AGENDA

CITY OF NORMAN, OK
HISTORIC DISTRICT COMMISSION MEETING
Municipal Building, Council Chambers, 201 West Gray, Norman, OK 73069
Monday, March 02, 2026 at 5:30 PM

ITEM TITLE: (HD 26-06) CONSIDERATION OF APPROVAL, REJECTION, AMENDMENT, AND/OR POSTPONEMENT OF AMENDMENTS TO CERTIFICATES OF APPROPRIATENESS 24-08 AND 25-04 FOR THE PROPERTY LOCATED AT 1320 OKLAHOMA AVENUE FOR THE FOLLOWING: A) MODIFICATIONS TO THE CONCRETE PATIO AND COVERED PERGOLA; B) MODIFICATIONS TO THE FRONT WALKWAY AND YARD; C) EXTENSION OF THE RETAINING WALL; D) CHANGE IN THE EXTERIOR WALL MATERIALS; E) THE ADDITION OF TWO EXTERIOR DOORS ON THE SOUTH SIDE OF THE STRUCTURE; F) MODIFICATIONS TO THE GARAGE DOOR DESIGN; G) MODIFICATIONS TO THE WINDOWS.

The applicant was approved for a new house, accessory dwelling unit, and a covered pergola at the March 8, 2025, Historic District Commission meeting. The applicant is now returning to the Commission to request modifications to the approved design for the property with the following amendments:

# SOUTH ELEVATION - NEW

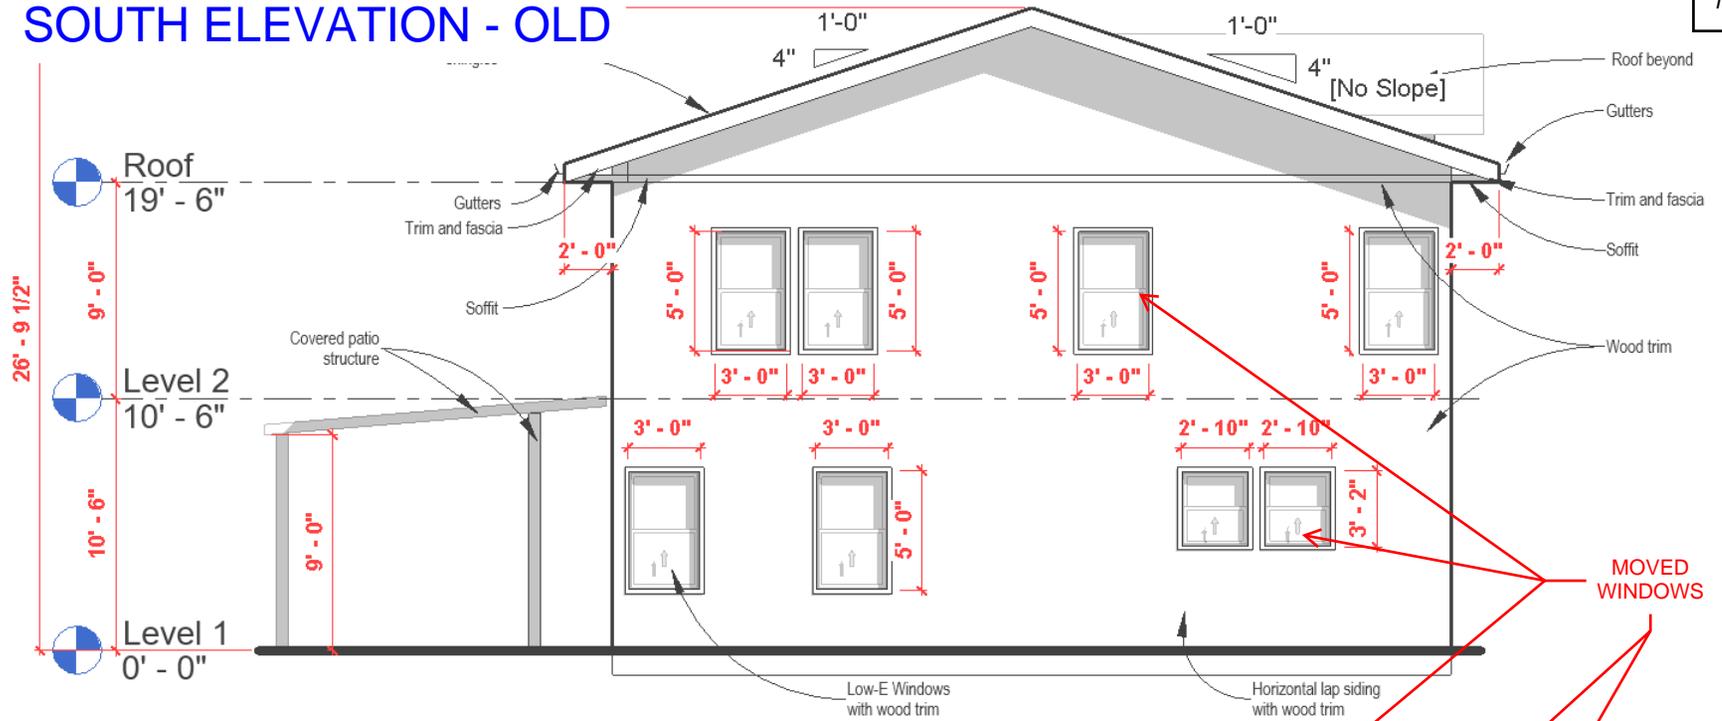
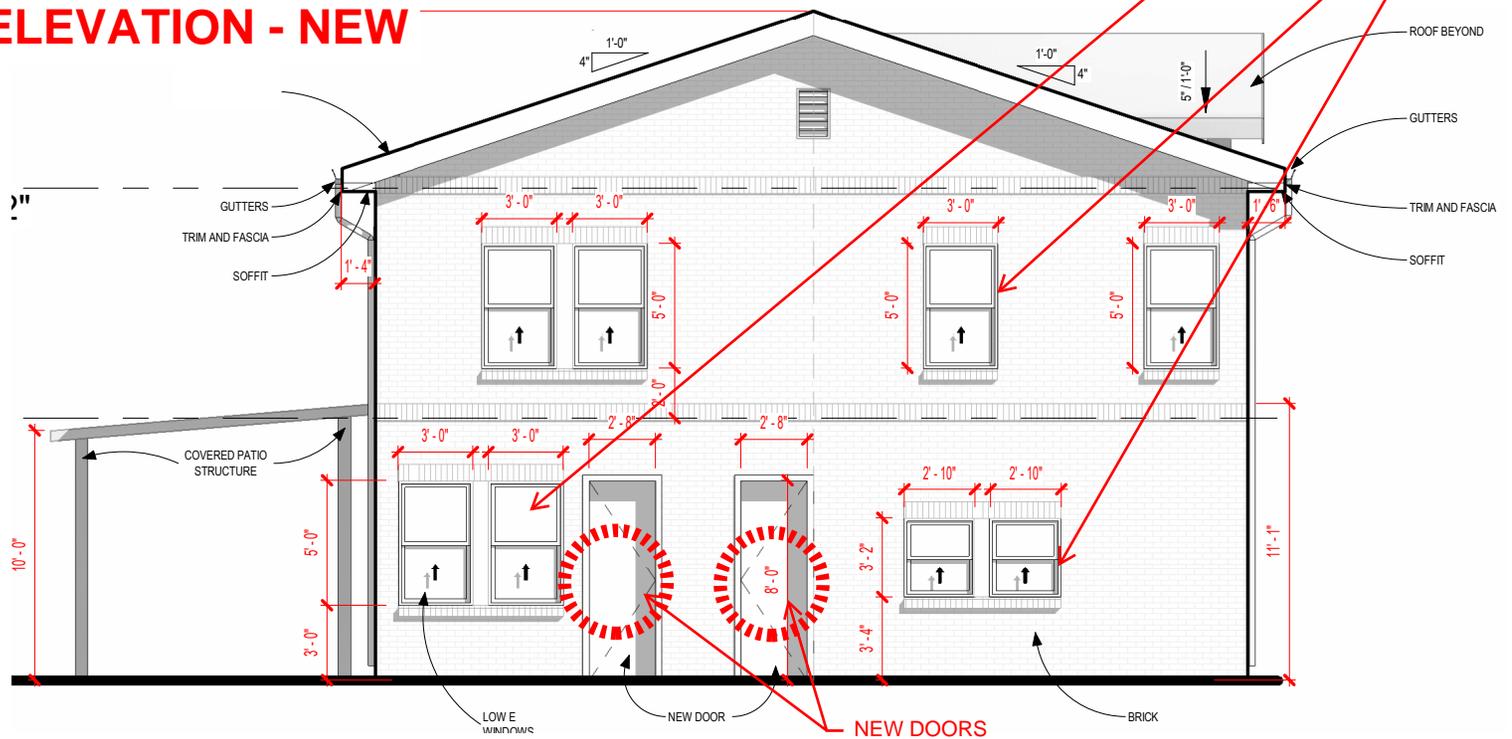
TWO  
NEW  
DOORS
